**No. EC155-67-013**

# SERVICE BULLETIN

#### Washer under the screw head of trim lever assembly

Corresponds to modification 0722B80 or 0767B73

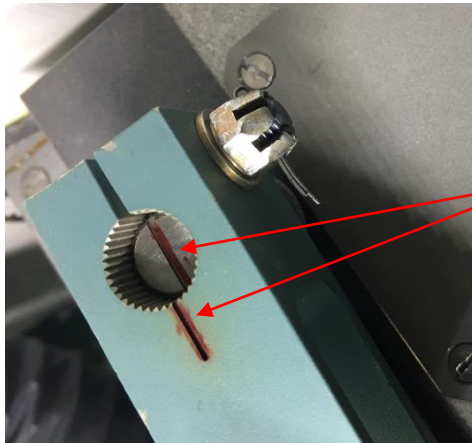
**IF THERE ARE NO MARKS ON THE TRIM LEVER AND ON THE OUTPUT SPLINED SHAFT OF THE TRIM ACTUATOR, IDENTIFY THE ANGULAR POSITION OF THE ONE RELATIVE TO THE OTHER (SEE THE EXAMPLE ON THE PICTURE BELOW).**

Figure 1

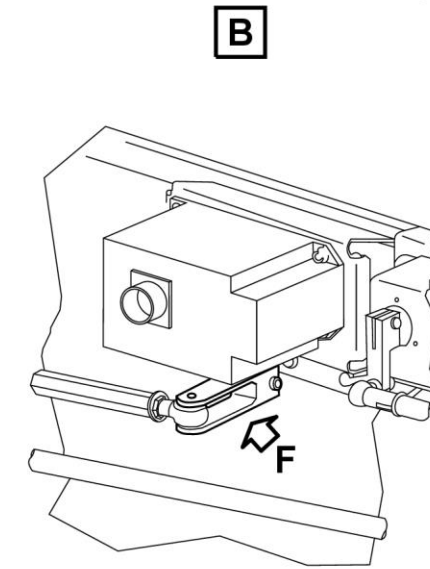
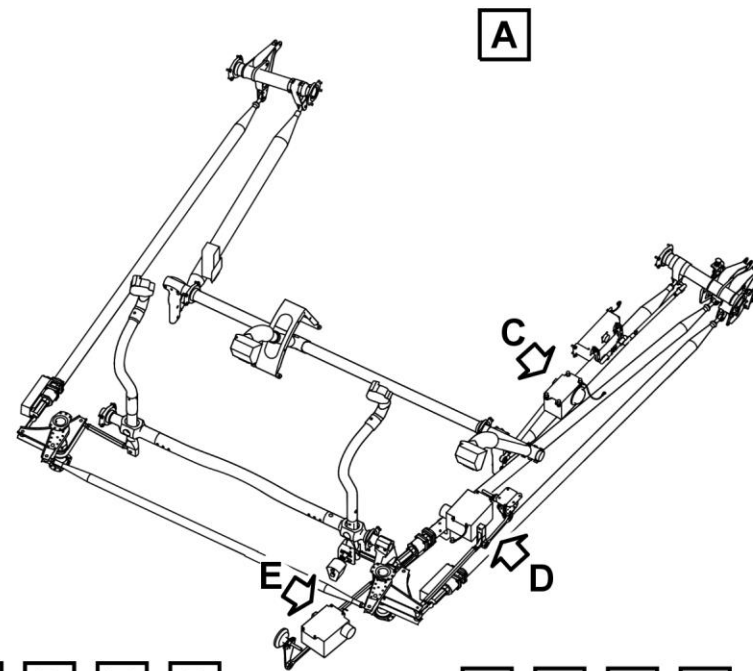
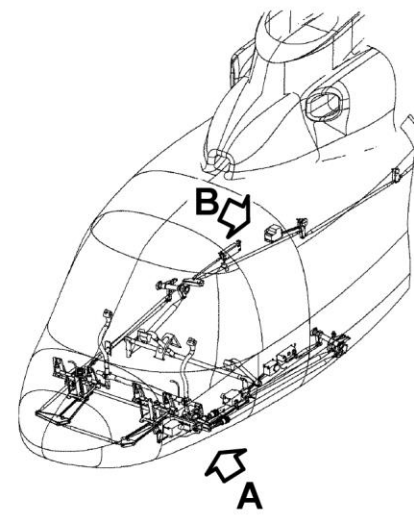
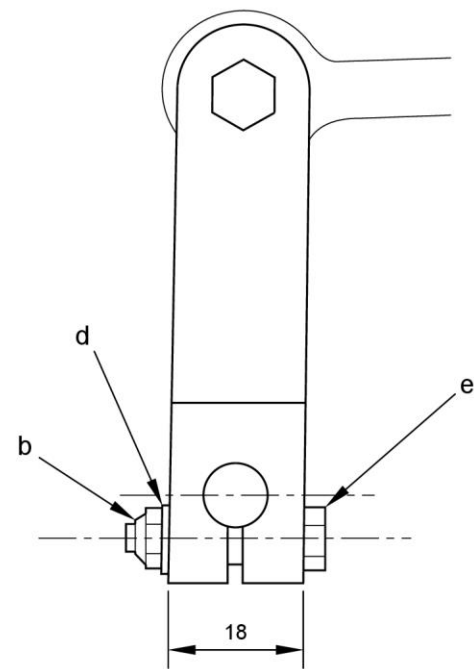
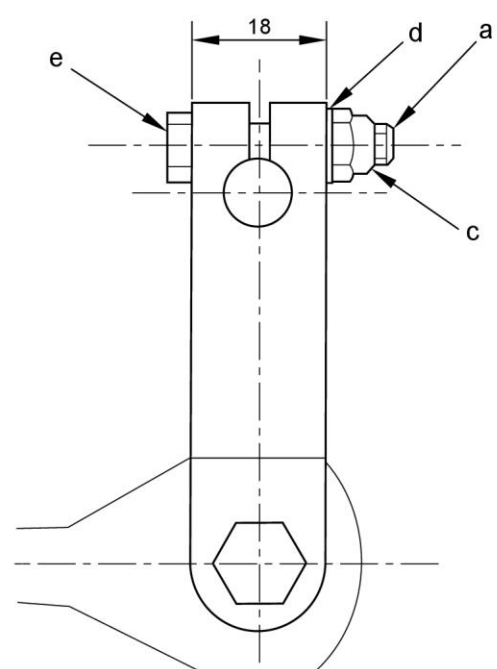
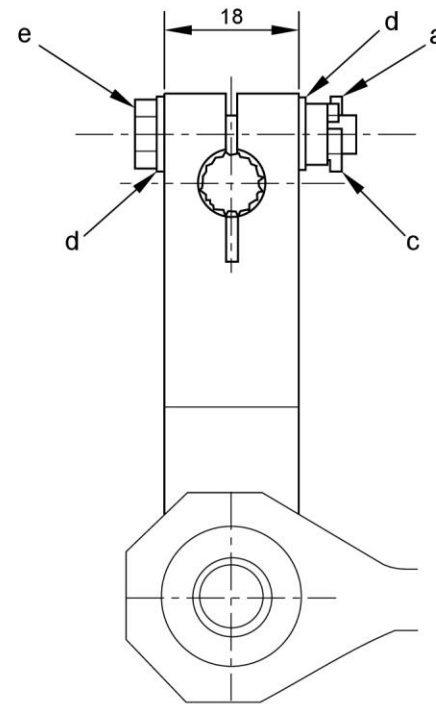
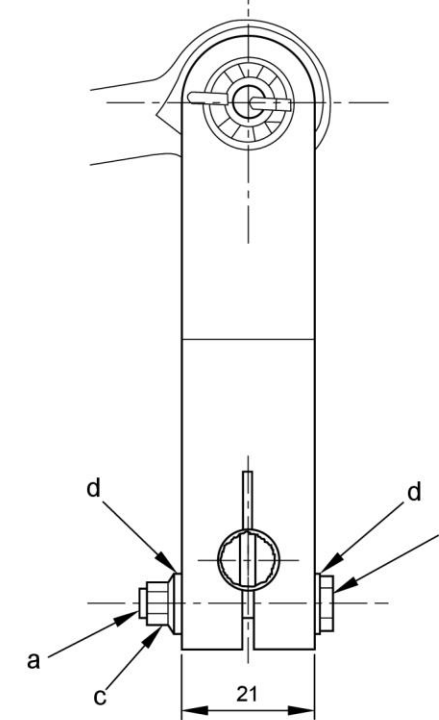
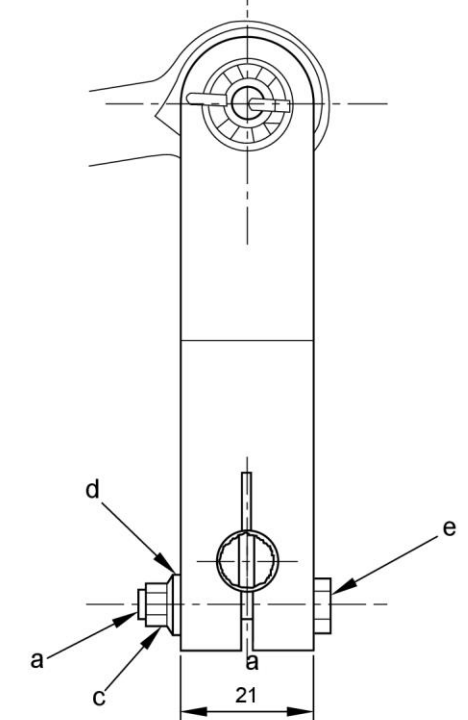
- Remove and discard ([Figure 1](#)):
  - . The pin (a)
  - . The self-locking nut (b)
  - . The castellated hex. nut (c)
  - . The washer (d)
  - . The screw (e).

*Figure 1 and type of lever will help you identify the items to remove.*

Figure 2

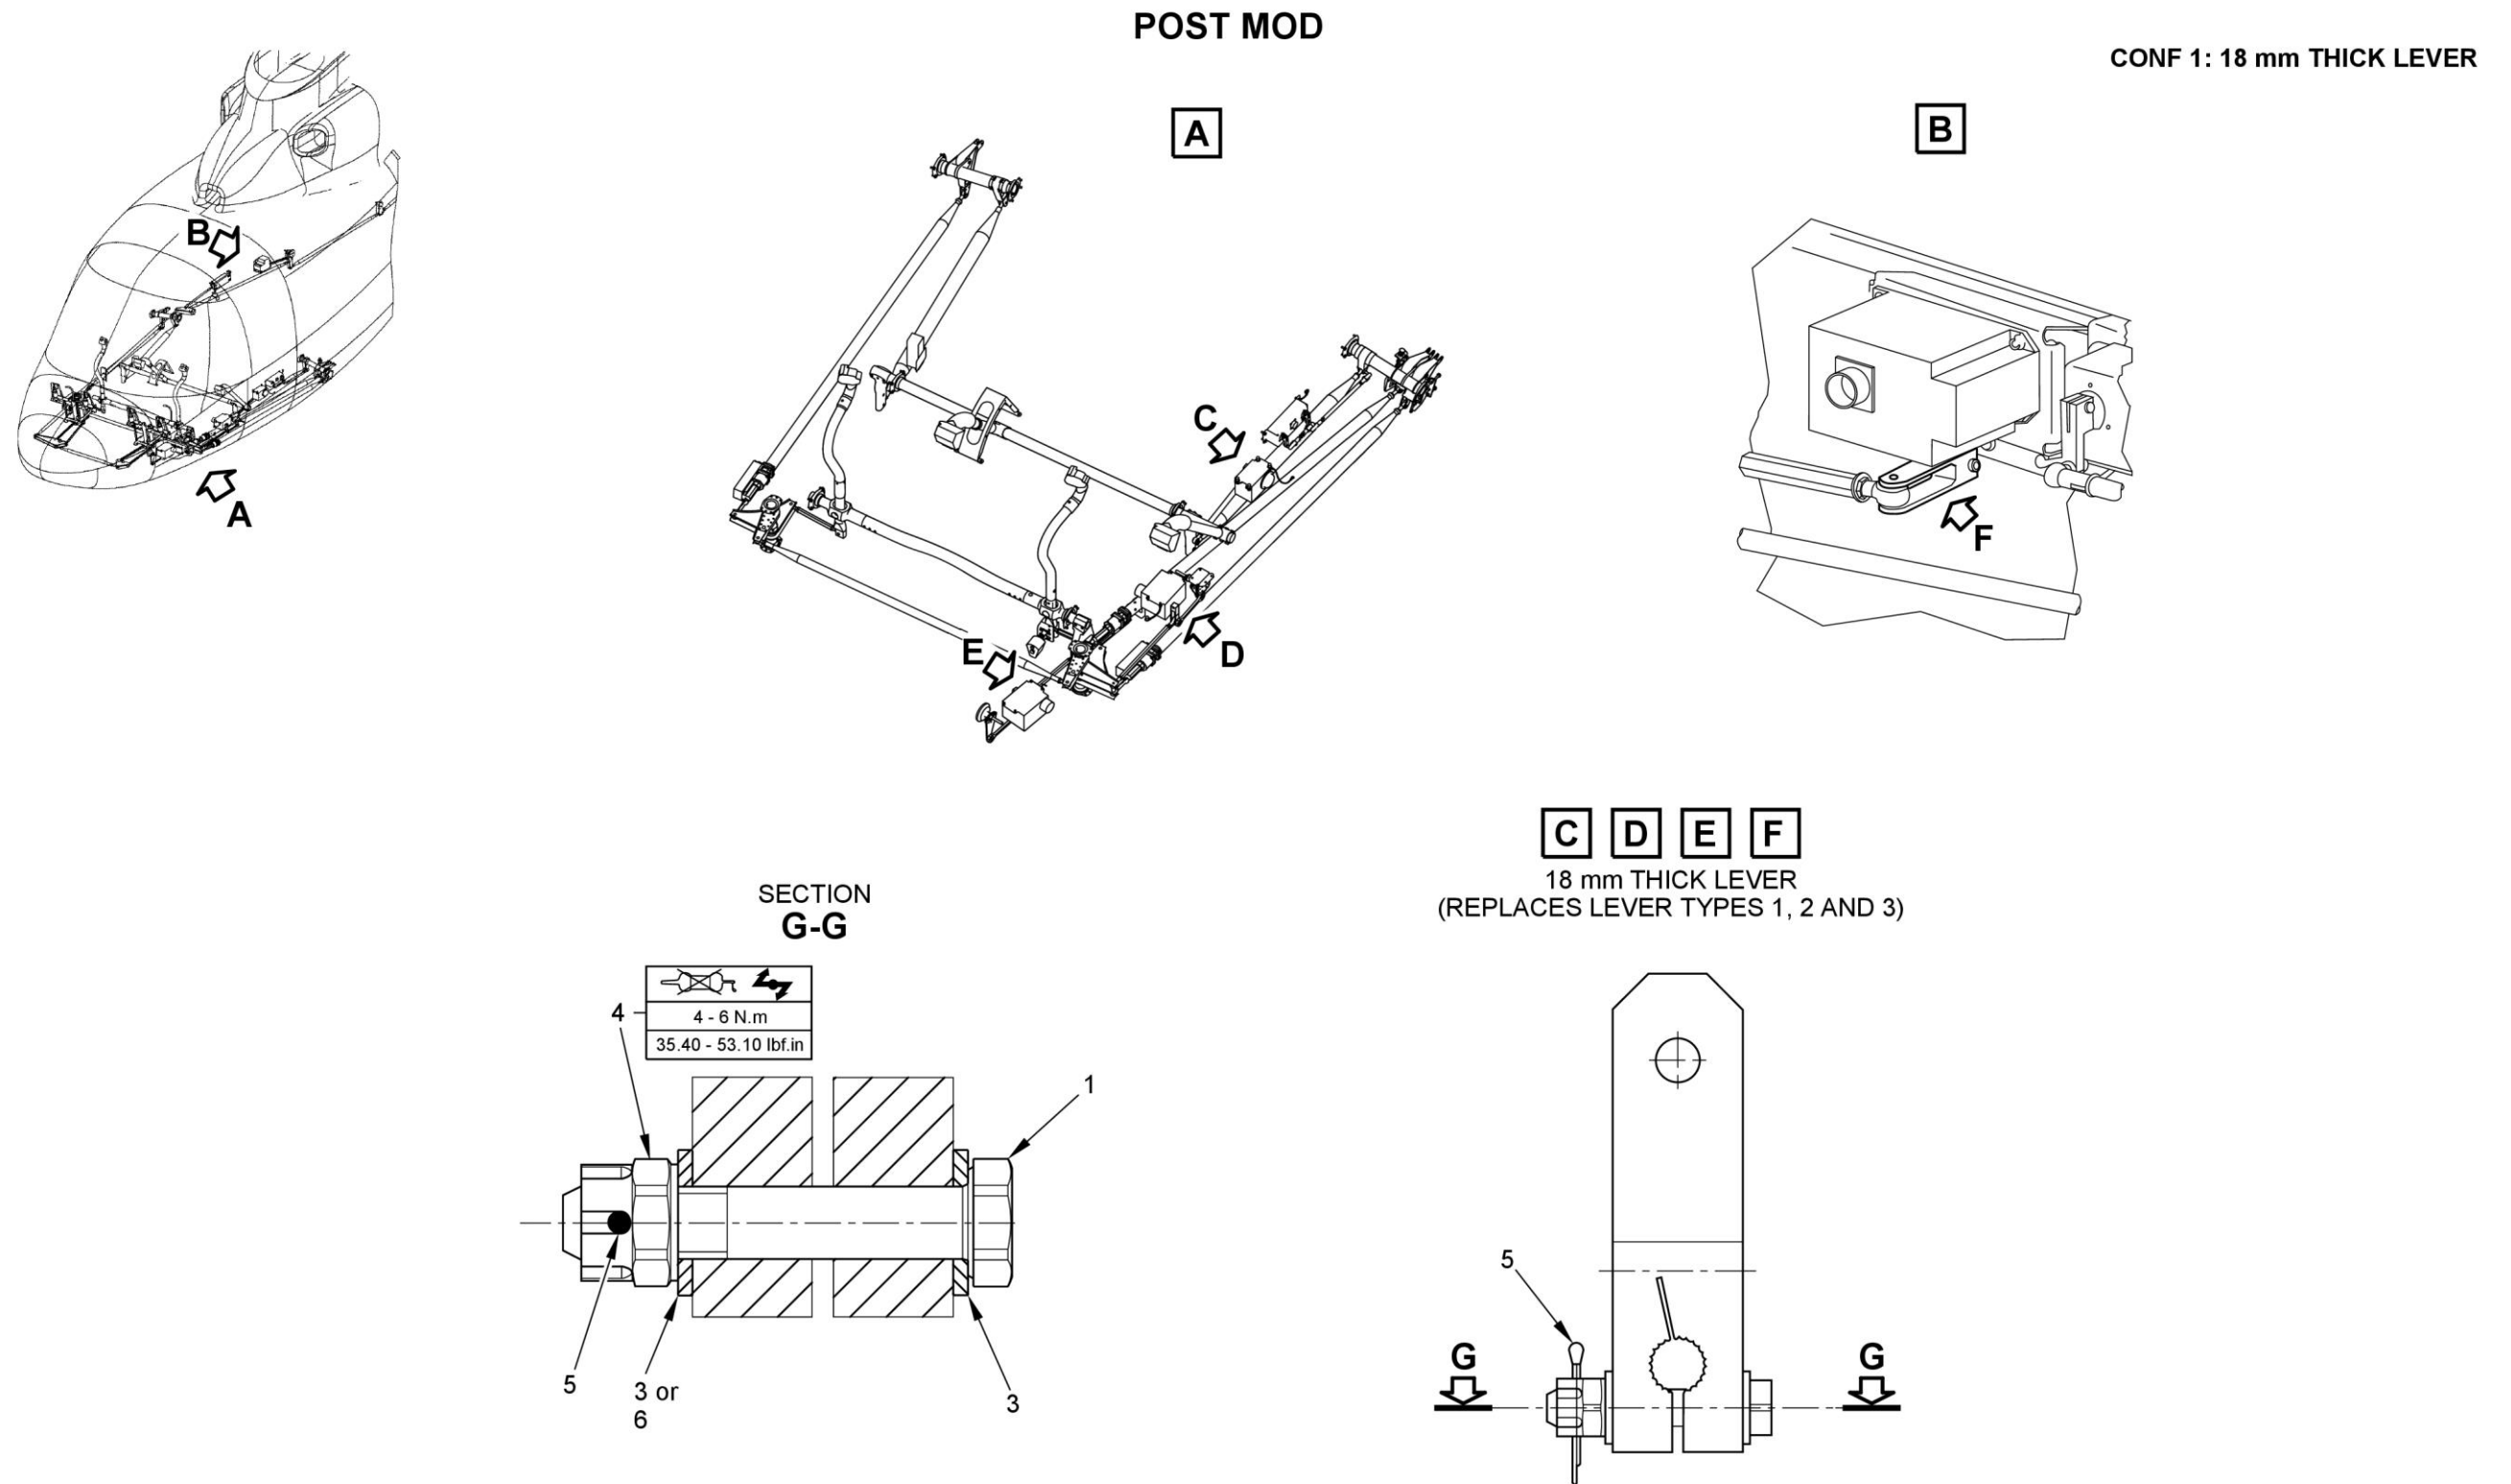
- Refer to the lever thickness to install ([Figure 2](#) or [Figure 3](#)):
  - . The bolt (1) or (2)
  - . The washer (3) or (6)
  - . The castellated hex. nut (4).

- For a helicopter with a 18 mm thick lever (CONF 1):  
365A08-9649-1071 ([Figure 2](#))
- For a helicopter with a 21 mm thick lever (CONF 2):  
365A08-9649-1171 ([Figure 3](#)).

- For 18 mm thick lever: It is possible not to use the washer (3) under the head of the bolt (1)
- For 21 mm thick lever: It is possible not to use the second washer (3) under the head of the bolt (2).

- Tighten between the minimum and the maximum value of the torque value range ([Figure 2](#) or [Figure 3](#)) until a slot of the castellated hex. nut (4) is aligned with the pin hole of the bolt (1) or (2). Refer to the lever thickness.
- Install the split pin (5).
